# **PALO ALTO PARK MUTUAL WATER COMPANY**

**Response to: 2017 Sanitary Survey Findings to items due 30 November 2017 and to immediate Actions**

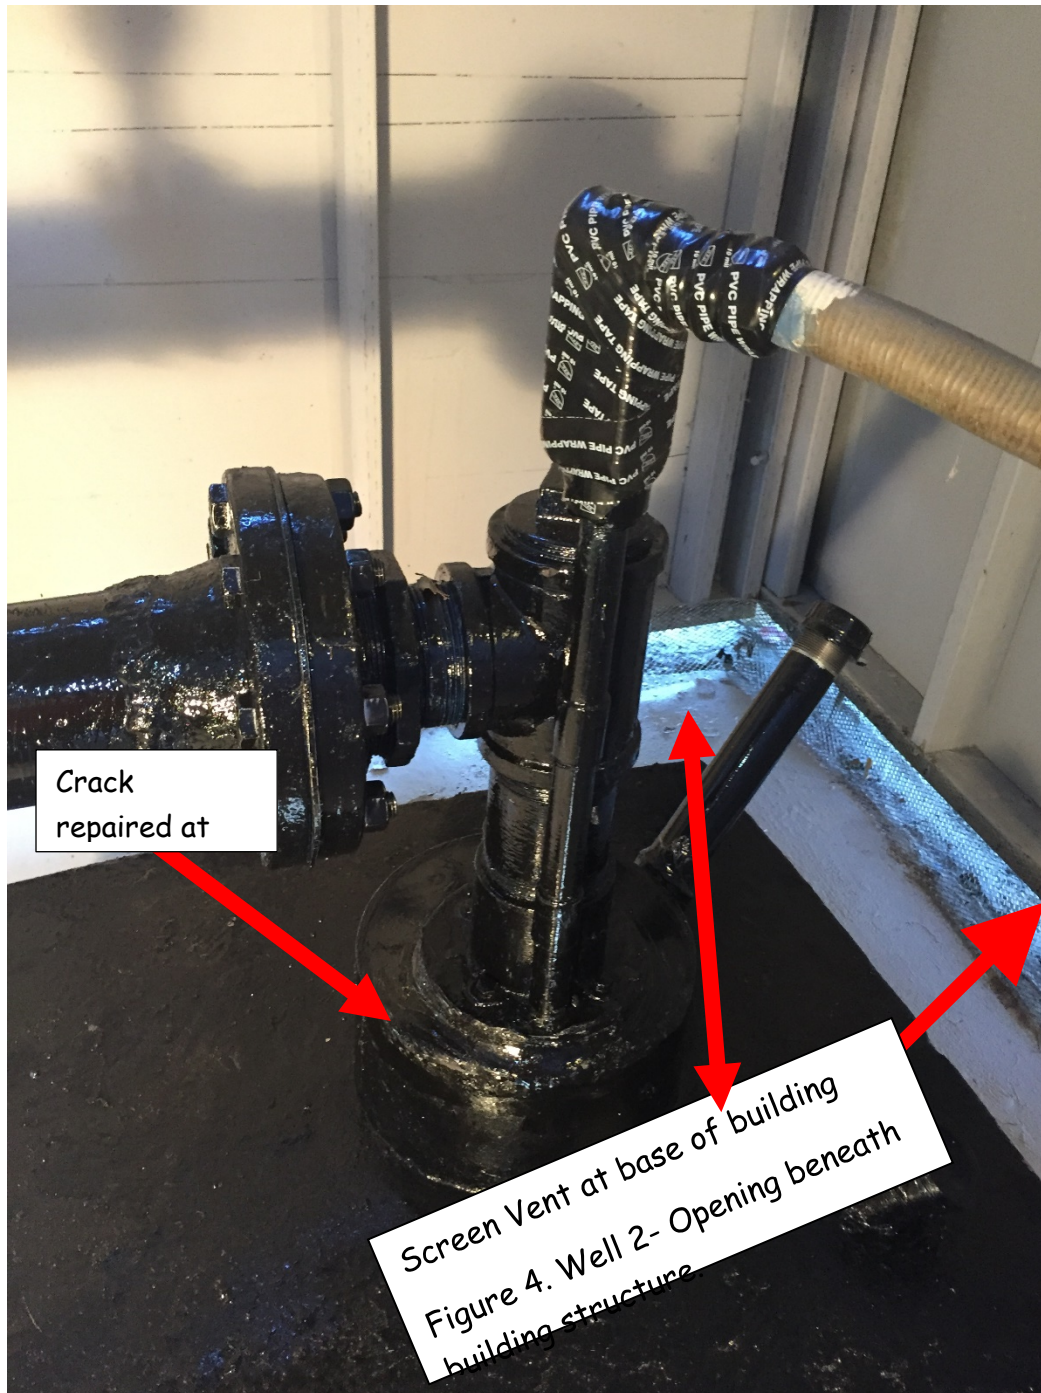
Review of the complaint forms indicate that PAPMWC has received several customer complaints regarding the taste, odor, color, turbidity and/or pressure of the water supplied to the community.

The forms however did not discuss the possible cause(s) of these issues, measures taken to address the complaints and results of the actions. Please discuss within the November 30, 2017 response letter PAPMWC's procedures for responding to and follow-up actions to address all customer complaints. All complaint forms must include sufficient information to demonstrate that the complaints were adequately addressed. Please submit as part of the Annual Report to the Division detail records of all customer complaints.

We have modified our complaint form to include a column for Possible Cause (s). Please find copies of PAPMWC ACTION in following up on a customer's complaint, notice left at property, a sample was collected, samples taken to State certified Lab. And a letter was mailed to customer with the results of sample collected a copy of a page from the Analytical Report and a page from 2016 SWS CCR Forms & Instructions, Regulated Contaminants with SECONDARY DRINKING WATER STANDARDS.
